Access Compliance Report

Public Rights-of-Way

Intersection ID: 49818	Main Street: LEES_CROSSING_DR	Cross Street: ASHLEY_VIEW_DR	Location: NW
ADA ID: CC705364A4FC	Ramp Type: PerpDiag	Initial Pass/Fail: Fail	Overall Compliance: No
		Severity Score: 17.5

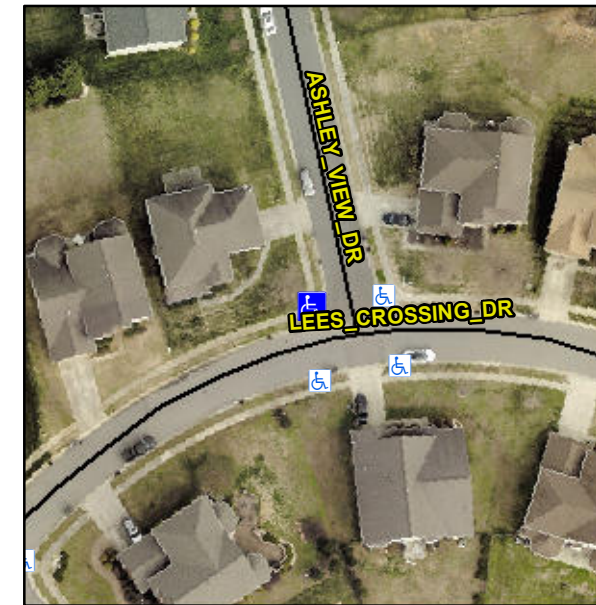
Surveyor Notes:

Not Found, R304.5.1

Remove & Replace Curb Ramp With Two New Directional Ramps or Equivalent.
